RE: Farmers Sand/Milton Reservoir M2024057- Adequacy Review #3 - Responses and Exhibits

Attached to this email is the Division's Adequacy Review #3 letter for the Farmers Sand/Milton Reservoir permit application, project number M-2024-057.

**Re: Farmers Sand, File No. M-2024-057 Receipt
of 112c Construction Materials Responses to
Adequacy Review #3**

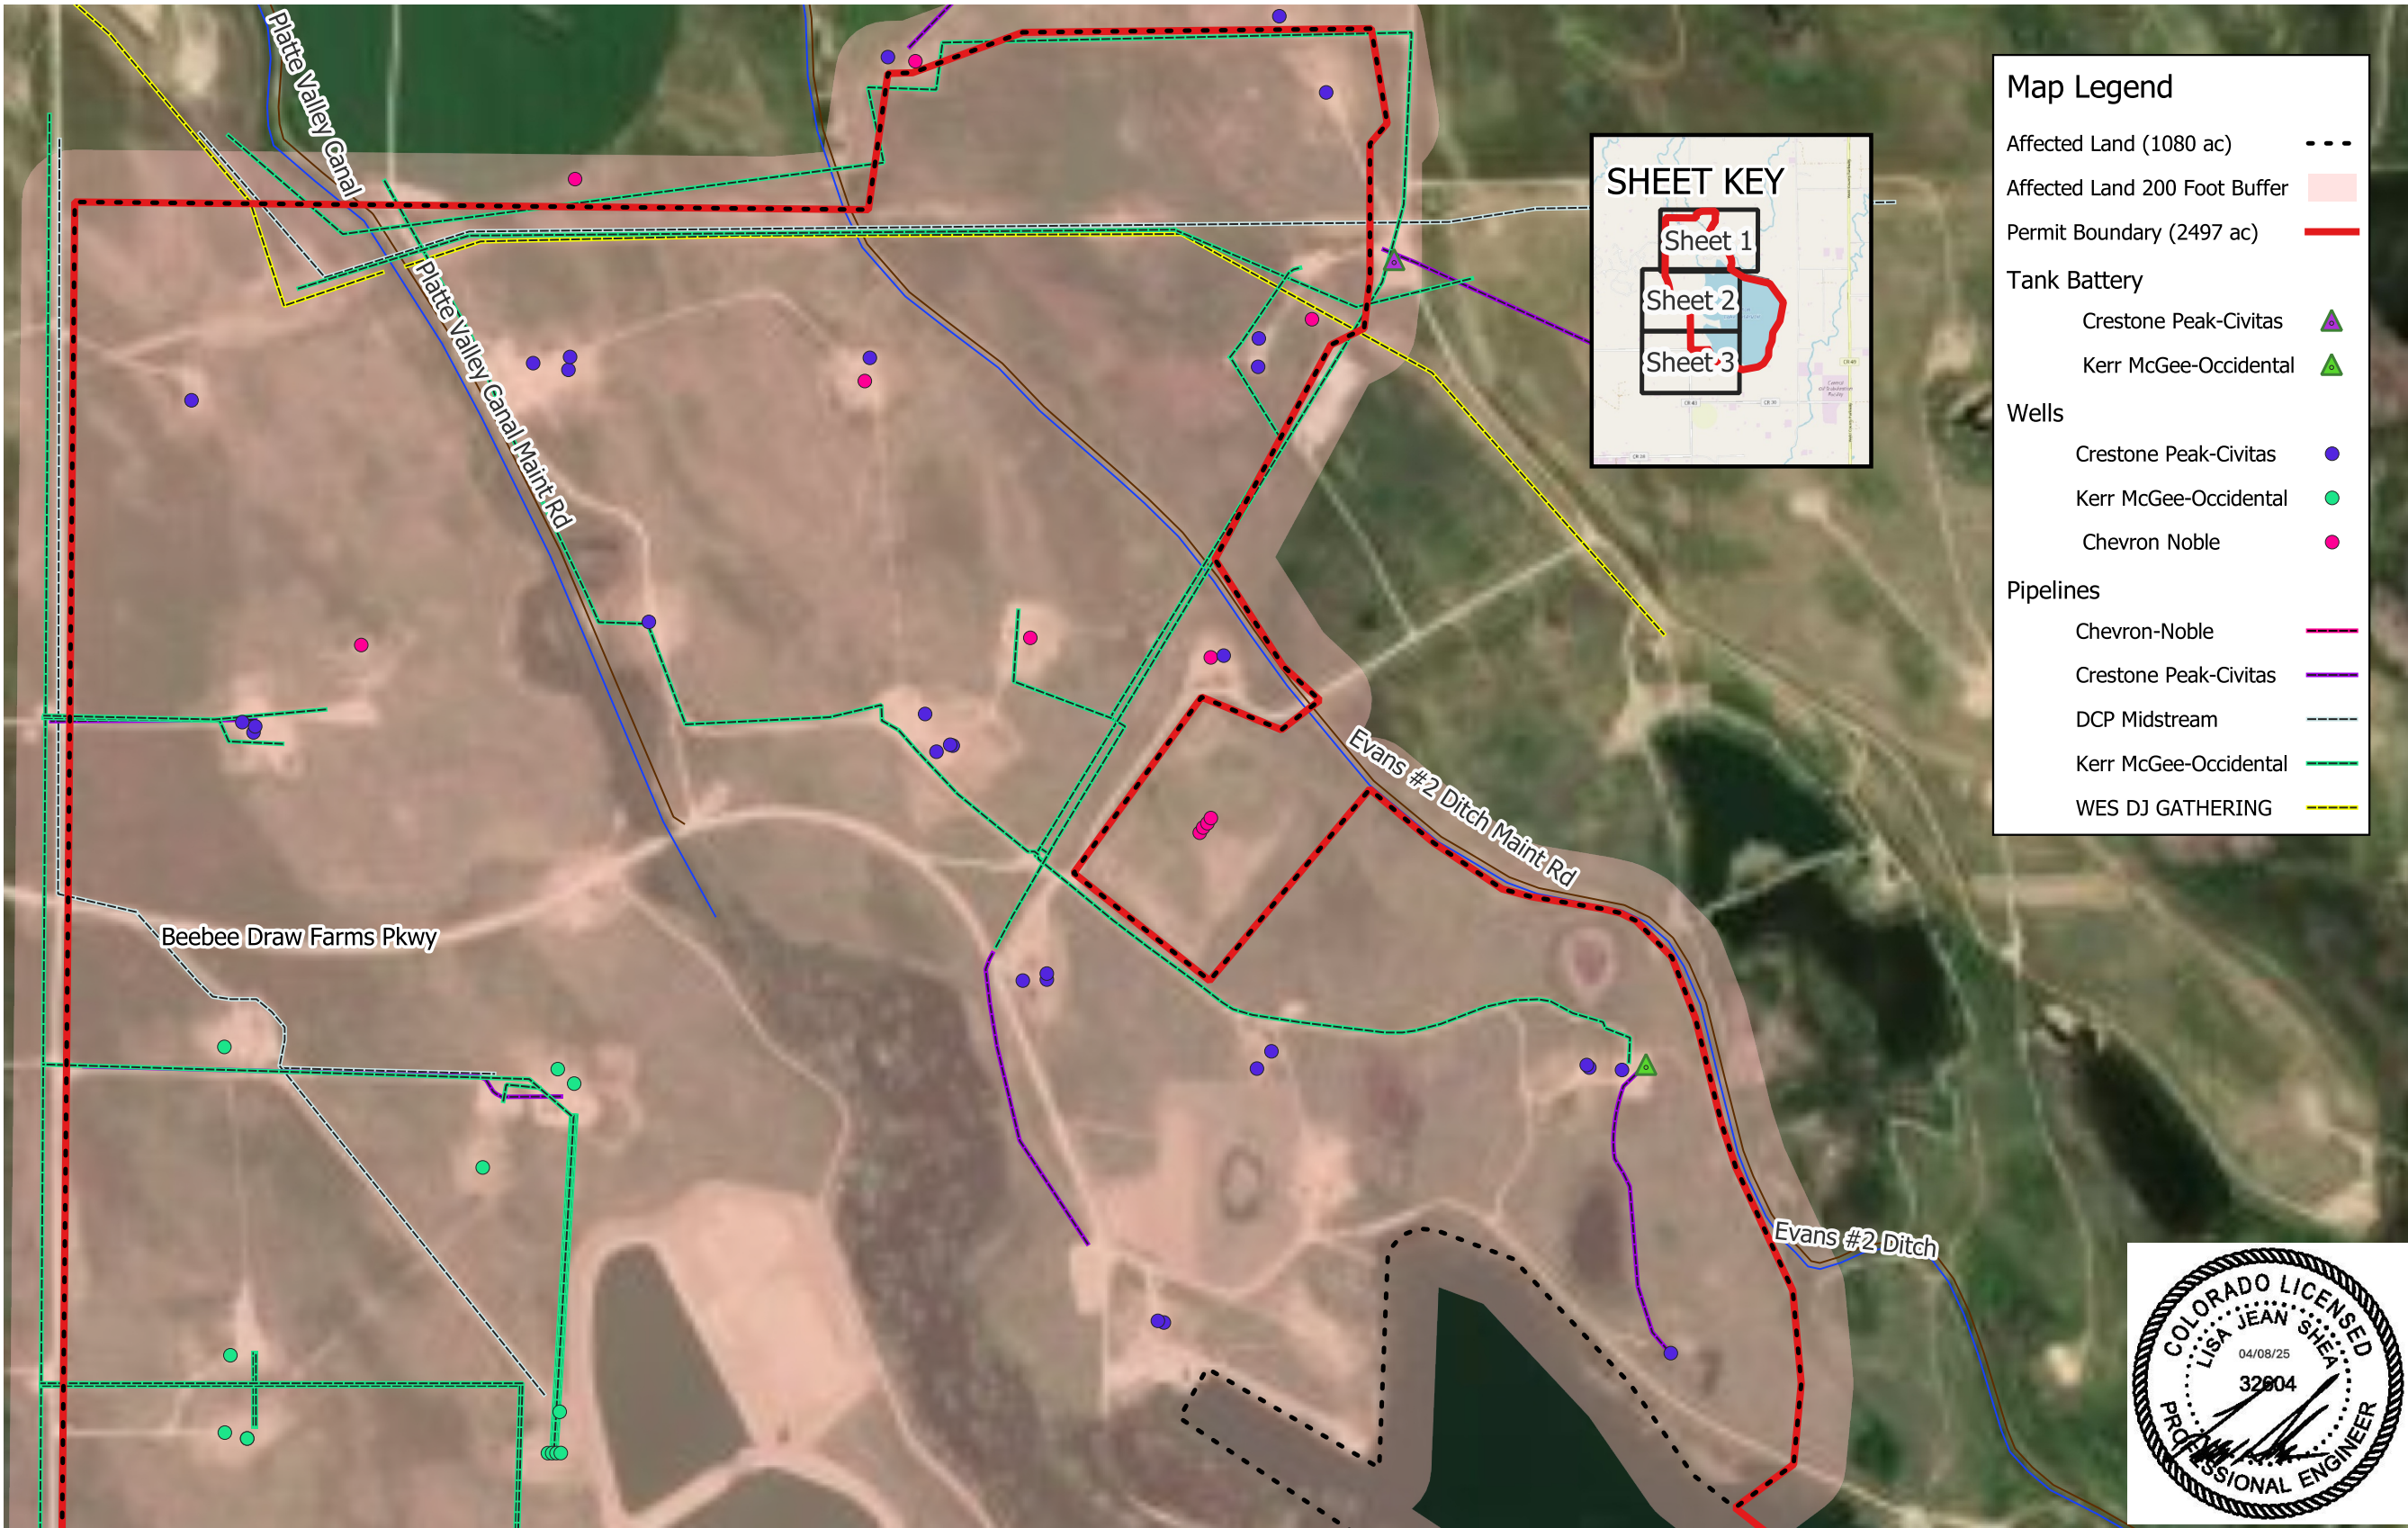
1. All the significant and permanent man-made structures have not been identified and depicted on the Exhibit C(g) map. Please update the Exhibit C(g) map to show the owner's name of the significant, valuable, and permanent man-made structures within 200 feet of the affected area. Further clarification regarding structures not sufficiently identified in the C(g) map is given in Item #55.

- b. **DRMS Response:** The owners of the pipelines are not shown on the map. Also, the Platte Valley Canal Maintenance Road, Beebe Seep Canal, Beebe Seep Canal Maintenance Road and the Evans #2 Ditch roads are not shown/labeled on the Exhibit C(g) Map. Please revise the maps accordingly.

- c. **FRICO Response:** The revised Exhibit C(g) Maps are included in attached Exhibit C.
 - d. **DRMS Response:** The revised Exhibit C(g) Maps do not include the maintenance roads for Platte Valley Canal, Beebe Seep Canal, and the Evans #2 Ditch. Please revise accordingly.

FRICO Response: Revised Exhibit C(g) Maps are provided in attached Exhibit C.
